PLAN COMMISSION / ZONING BOARD OF APPEALS AGENDA

Project: Abbey Woods North
Meeting Type: Public Hearing
Requests: Rezoning (upon annexation), Preliminary Plat of Subdivision, relief from Design Standards for cul-de-sac length and wall length, relief from Land Subdivision Regulations for cul-de-sac length and stub street connection, review of variations for lot width & depth
Location: South side of St. Francis Road, just east of La Grange Road
Applicant: O'Malley Builders Inc.
Prop. Owner: Steven Beemsterboer
Representative: Shawn O'Malley
Staff Reviewer: Christopher Gruba, Senior Planner

ABBEY WOODS NORTH
STEVEN BEEMSTERBOER
9433 ST FRANCIS ROAD FRANKFORT, ILLINOIS
PRELIMINARY PLAT

SHEET NO.	2a	OF	3
-----------	----	----	---

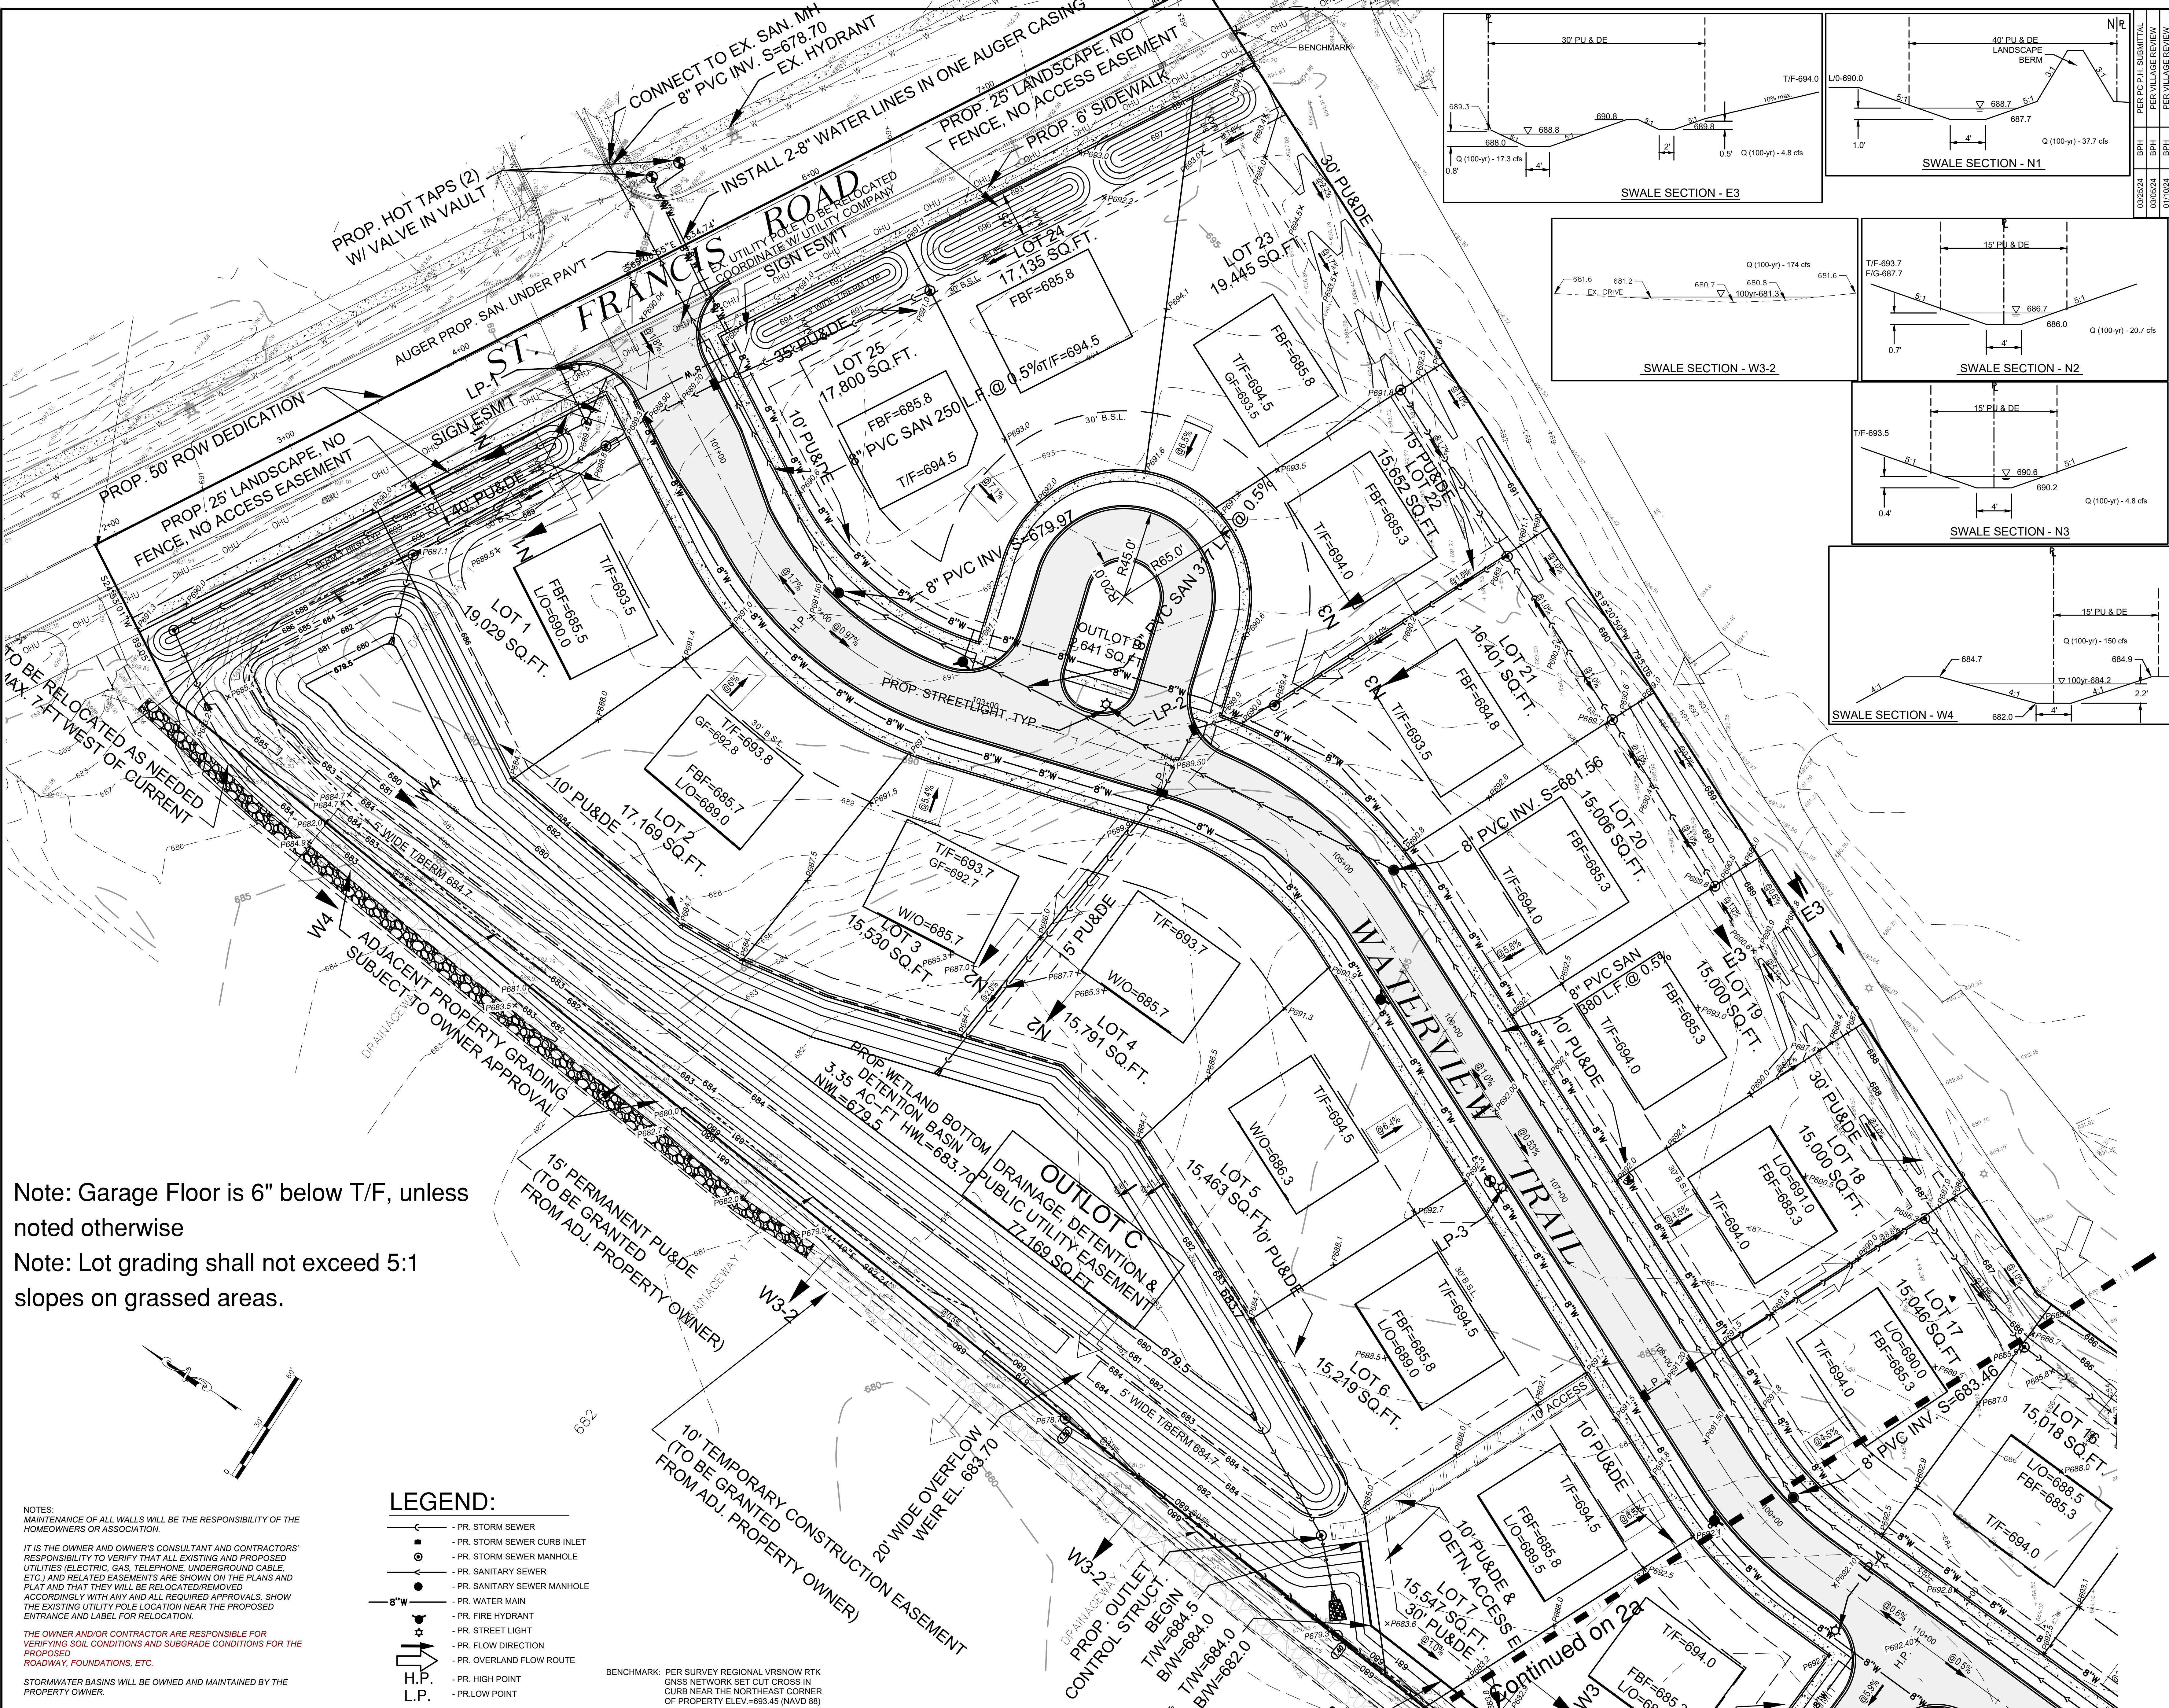
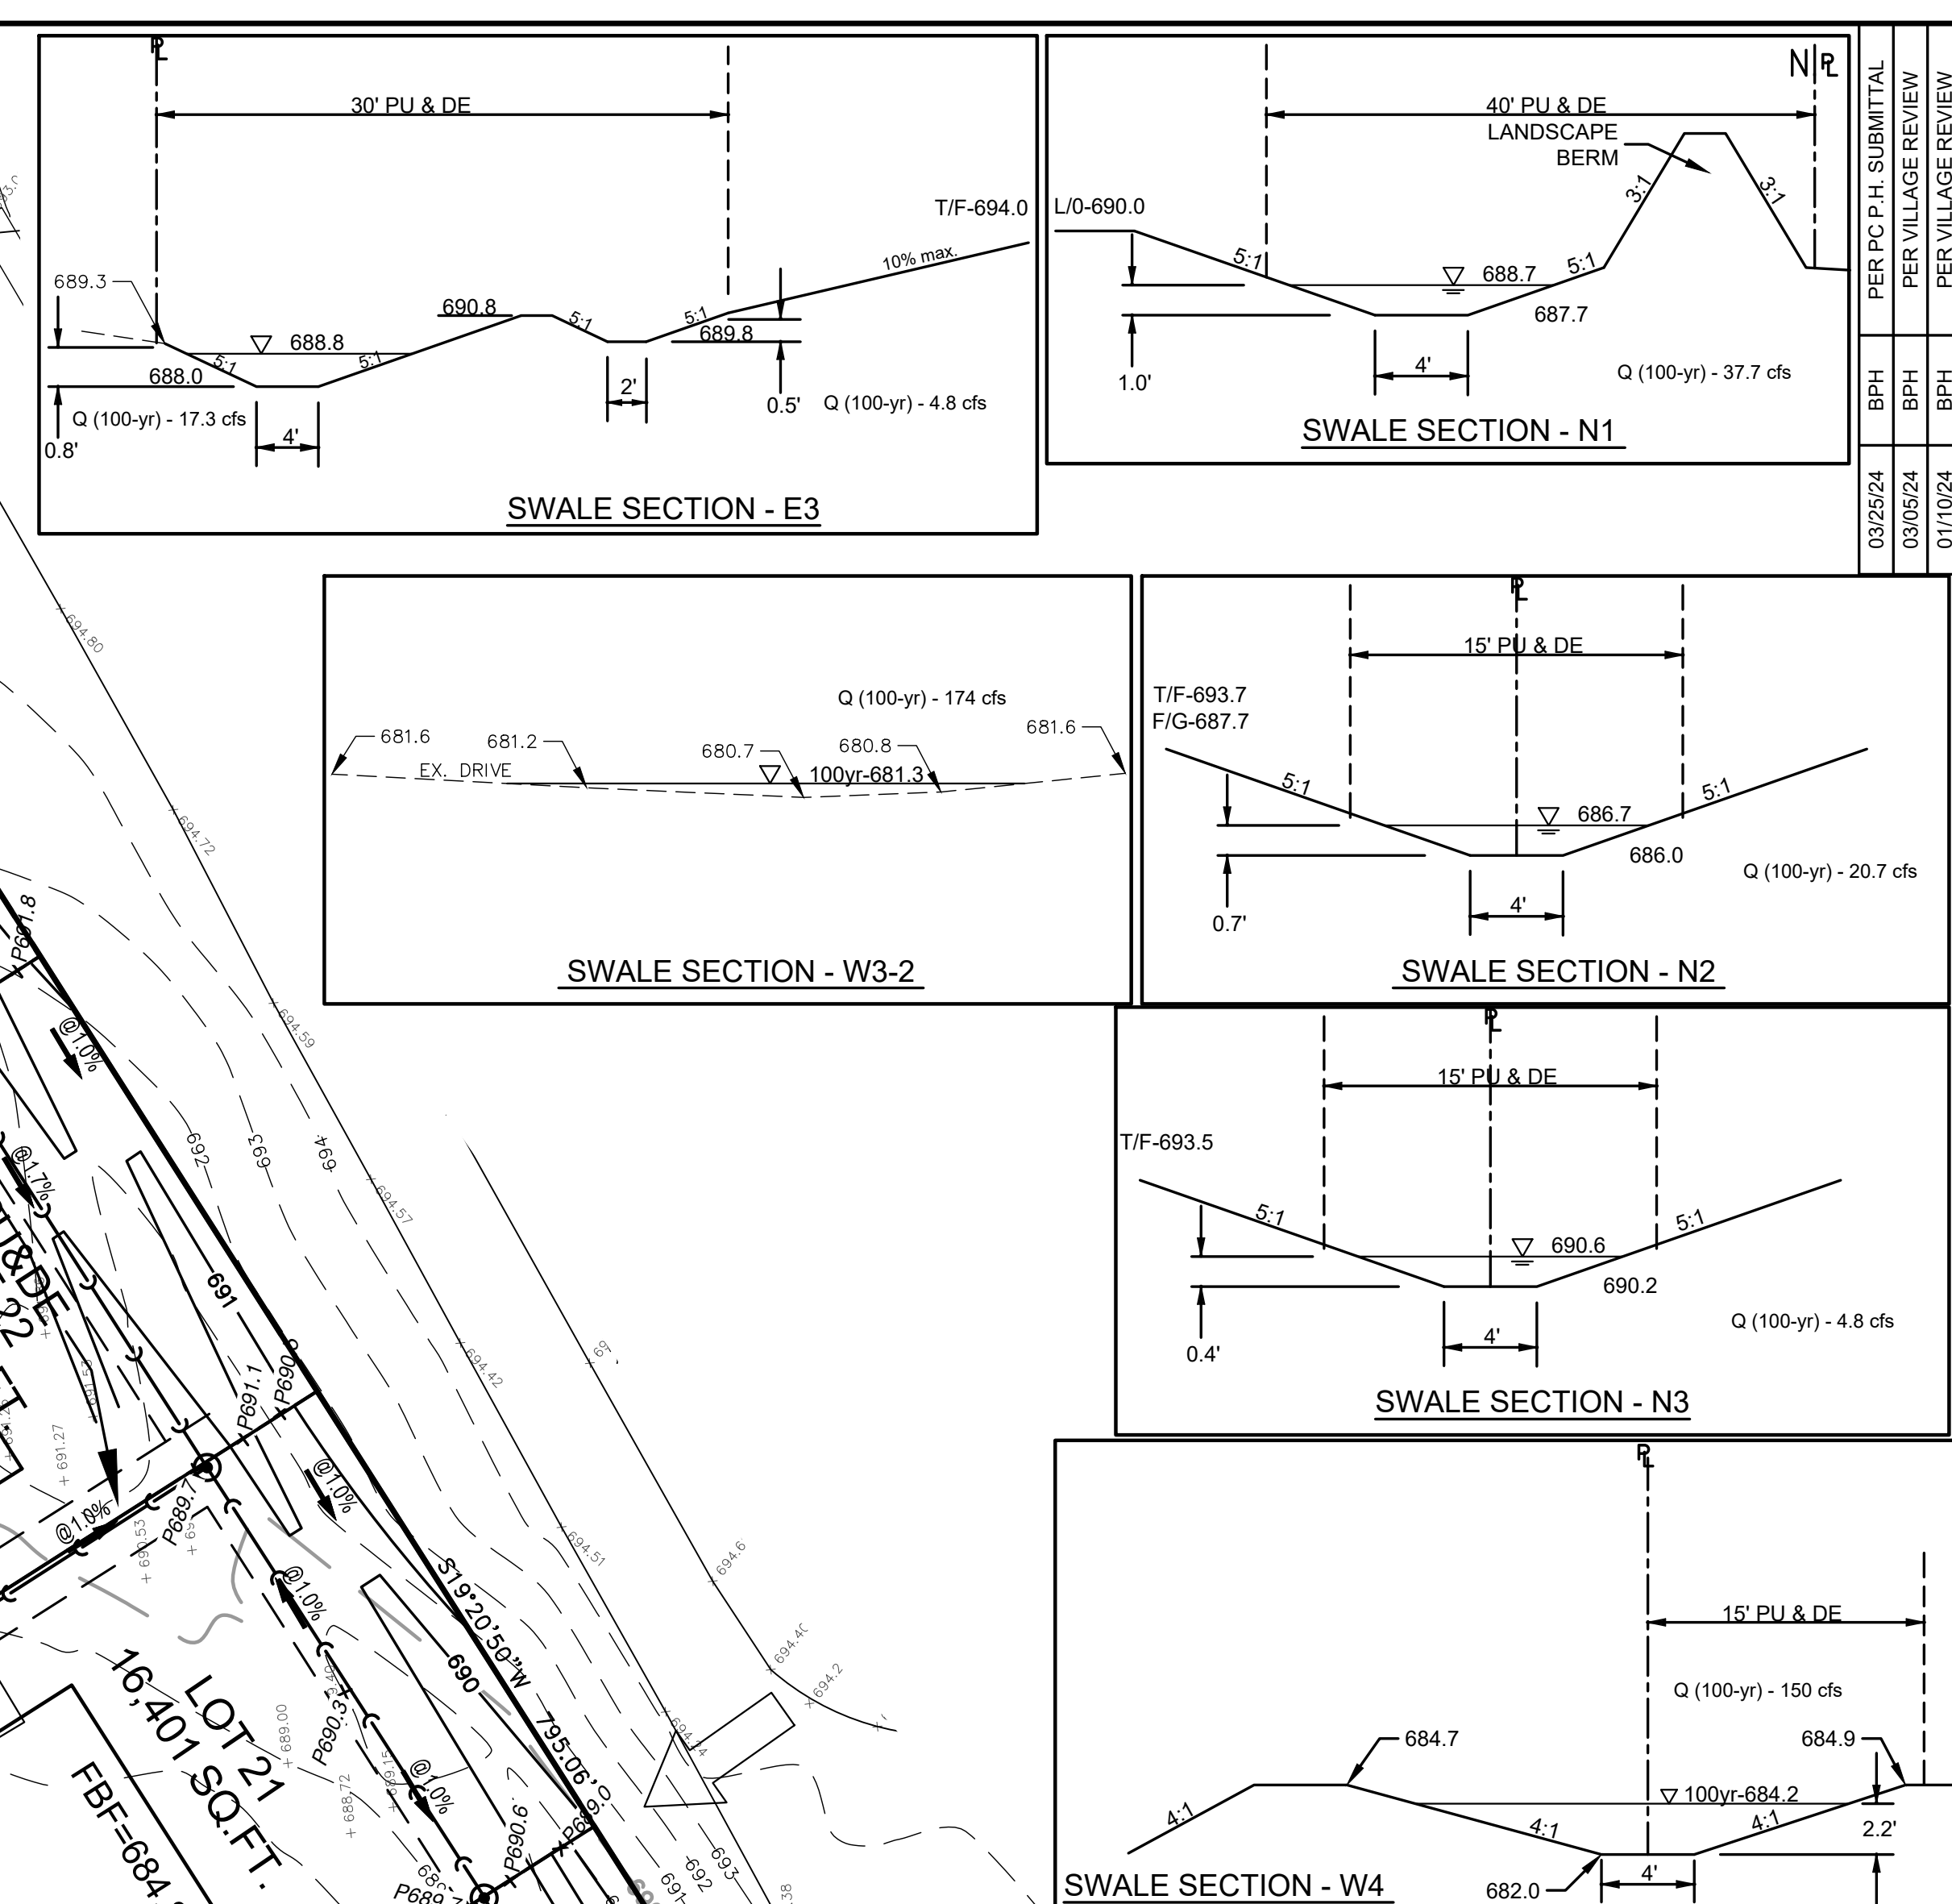
- iii. Walls with 2.5' height or greater and/or 50' length must be approved by the Plan Commission.
 - iv. Walls with 2.5' height or greater require a railing. For conformity, Village Staff recommends including a railing along the walls in Lots 7-11. Please confirm railing materials with Village Staff.

- v. Add "No Fence Easement" to the PU&DE in lots where walls and swales are proposed (east and west).
 - vi. Maintenance of all walls will be the responsibility of the homeowners or association.

- H) *The following grading and drainage clarifications will be required during final engineering:*
- i. *Revised calculations are needed for the capacity along the west property line, including ponding depth over the new inlets. Revise the north pond outlet to connect to the proposed storm sewer rather than daylight with a flared end section and rip rap.*

- ii. *The following stormwater calculation will need to be confirmed with final engineering: Section E2 will not be allowed to increase the flow depth. The stations and elevations used offsite vary between existing and proposed conditions. Provide existing topography with the cross-section location.*

- iii. *Arrows showing drainage patterns on the Drainage Area Exhibit and Preliminary Plans do not represent actual existing or proposed conditions. Based on the provided topography and county topography, there appears to be sheet flow towards the rear property lines of Lots 17-23.*
